RE: Wawa – Preliminary Plan
Wayne Property Acquisitions Inc. – Applicant

Gannett Fleming, Inc. has completed a review of the Preliminary land development plans for compliance with the Radnor Township Code. These Plans was reviewed for conformance with Zoning, Subdivision and Land Development, and other applicable codes of the Township of Radnor.

Reference: Wawa – 302-306 E. Lancaster Avenue (S.R. 0030) & Aberdeen Avenue
Preliminary Land Development Plan Review 1
2018-D-04
Radnor Township, Delaware County, PA
G&A 18-06057

SHEET TITLE:
LANDSCAPE PLAN
 SHEET NUMBER:
7
 OF 19
 REVISION 0 - 2018.07.13

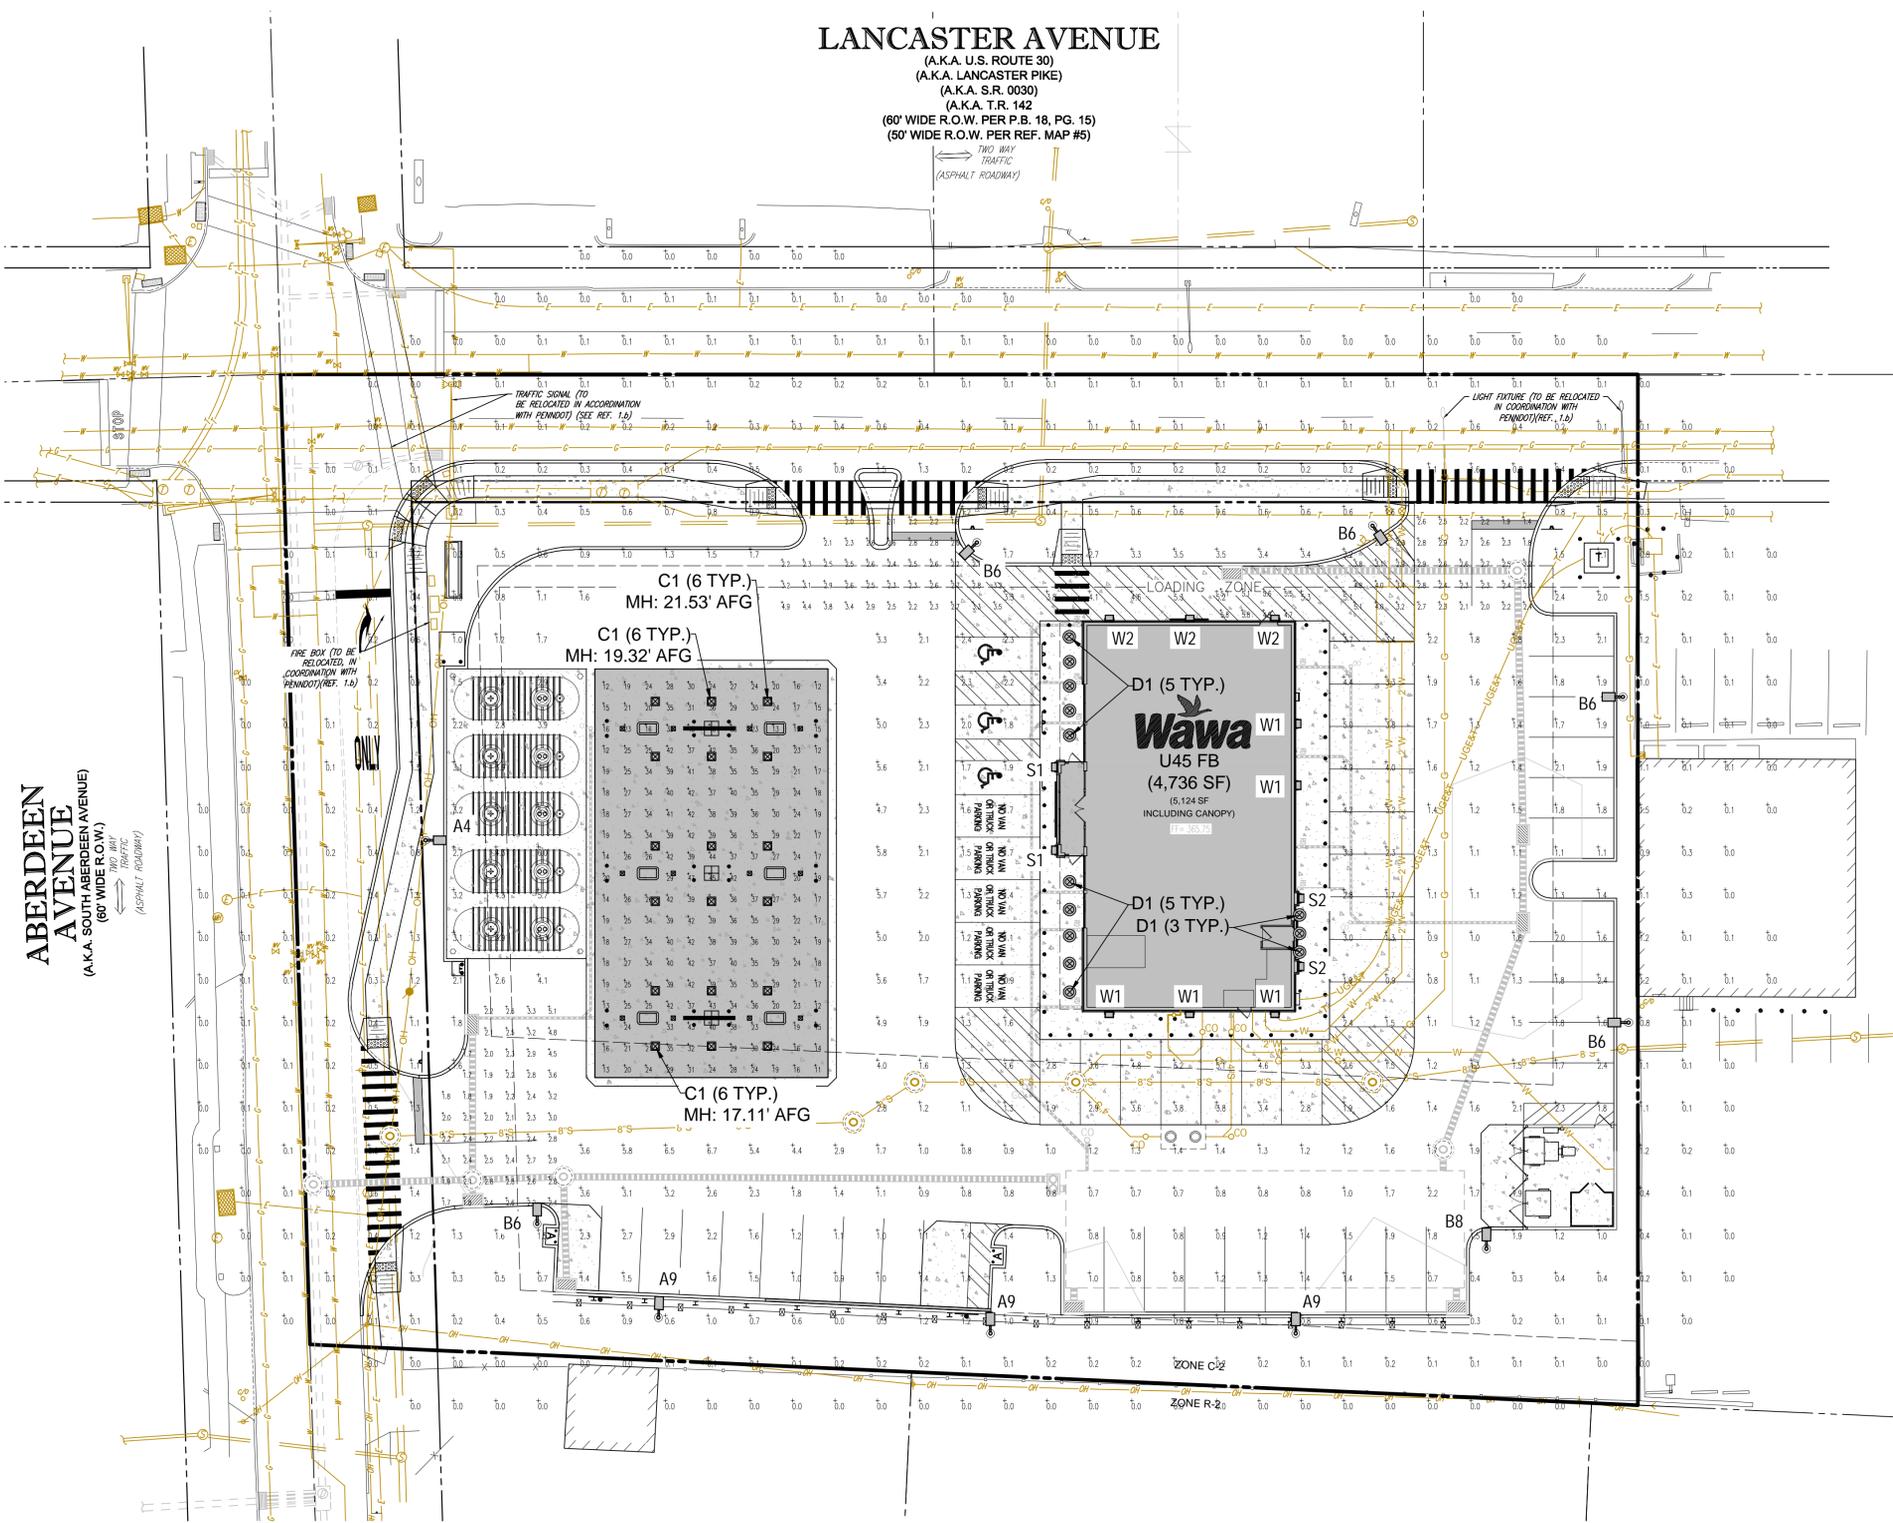
15. §255.39.B – Street trees 2 ½ inches dbh at intervals of not more than 30 feet along both sides of new streets and along one or both sides of an existing street within the proposed subdivision or land development. The applicant has excluded the driveway width in the street tree calculations on sheet 7. This must be revised, or a waiver requested.

CULTEC INTERNAL MANIFOLD - OPTIONAL INSPECTION PORT DETAIL

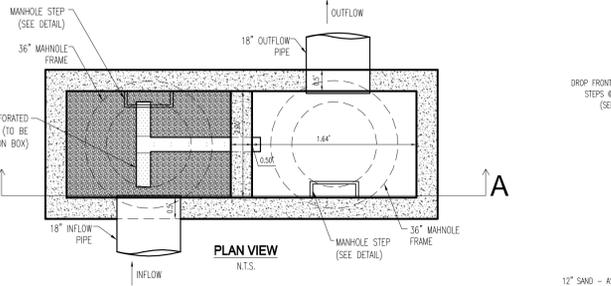
The proposed Cultec Recharger 280HD has an open bottom design which would permit untreated stormwater to leave the system, which is not permitted for stormwater hotspots. The stormwater system must be redesigned such that no stormwater can infiltrate into the ground. In addition, we note that the geotechnical report in Appendix A found a high water table at the site which inhibits the natural filtration of stormwater. Therefore, no stormwater shall leave the site uncontrolled without first being filtered to remove oil contaminants.

S6 MANHOLE FRAME DETAIL
SCALE: N.T.S. REV: 2015.03.09

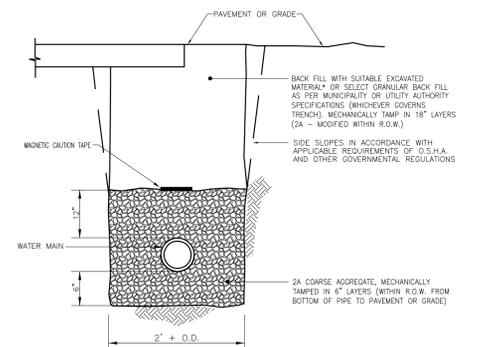
4. The manhole frame and cover detail on sheet 17 of 19 must be replaced with the Radnor Township frame and cover detail.

AIR PUMP STAND

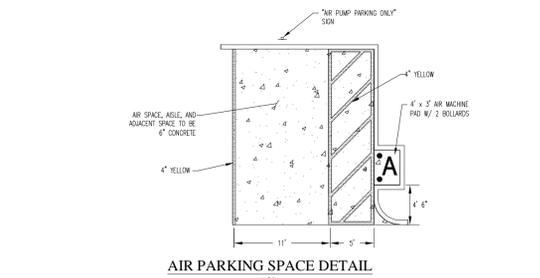
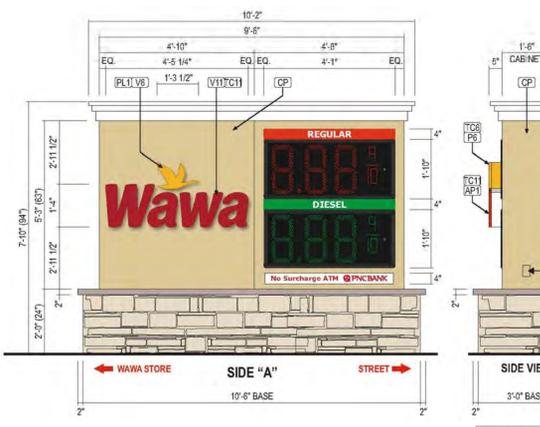
6. The air machine and associated concrete pad located adjacent to the Aberdeen Avenue entrance does not match the detail on Sheet 18 of the plans. Revise the plans and/or detail sheet accordingly.
